**Rio Mesa Solar Electric Generating Facility (RMSEGF)
(11-AFC-4)**

**Applicant's General Comments and Comments to Conditions of Certification
on the Preliminary Staff Assessment**

VISUAL RESOURCES

Figure 3 – Several Major Population Centers in Relation to Project Power Towers

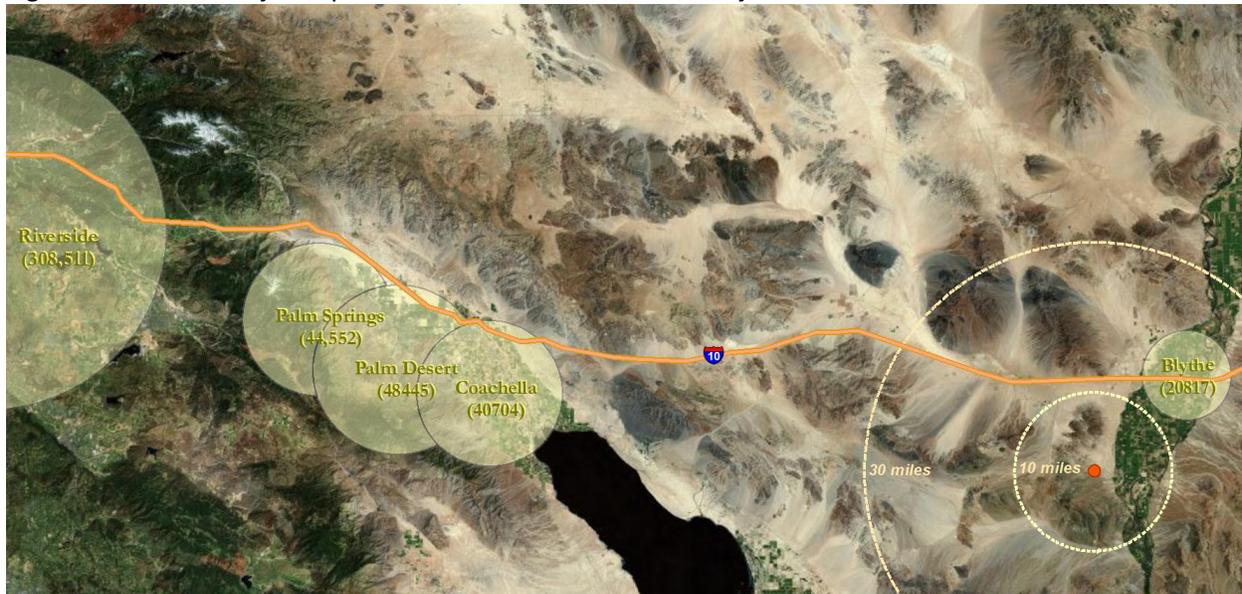
Municipal or County Population Center	Population Total (US Census, 2010)	Represented as Percent of Pop (328 people) within 8 miles of the Project	Represented as a Percent of the Population (21,217) within 20 miles of the Project
Blythe	20,817	1.57%	101.9%
Coachella	40,704	0.80%	52.12%
Palm Desert	48,445	0.67%	43.79%
Palm Springs	44,552	0.73%	47.62%
Riverside	308,511	0.10%	6.8%
Riverside County	2,189,641	0.014%	0.96%
Imperial County	174,528	0.18%	12.15%
Riverside and Imperial Combined:	2,364,169	0.013%	0.89%
Source: US Census, 2010. URS, 2012.

The PSA identifies sensitive viewers within the Palo Verde Valley as residents in around Palo Verde and Ripley and motorists on SR-78.
